Subject: FW: 1 Guilford Street

Subject: RE: 1 Guilford Street

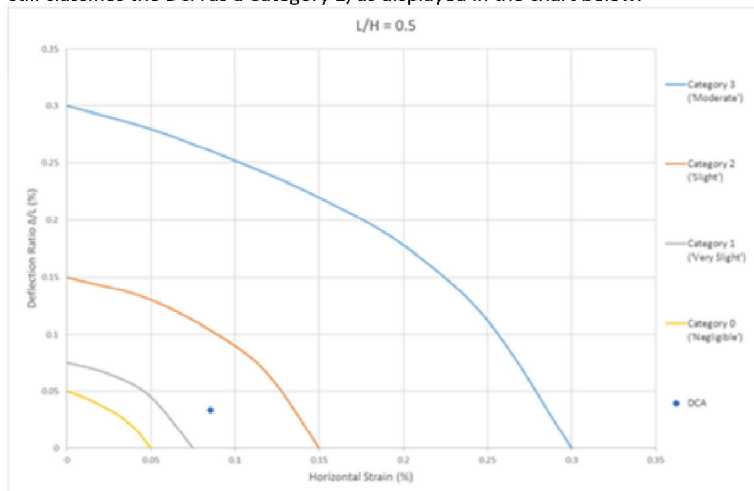
I believe Campbell Reiths concern is with the removal of the Ball et al correction from the Damage Category Assessment (DCA). Removing this will base the DCA on CIRIA C580 guidance only as no settlement is predicted near this location.

This will only affect the horizontal strain in the assessment, increasing it to $\epsilon_h = 8.53 \times 10^{-4}$ (0.085%). This increase still classifies the DCA as a Category 2, as displayed in the chart below.

We can therefore confirm that the ground movements cause a *maximum* of Damage Category 2 in adjacent structures.
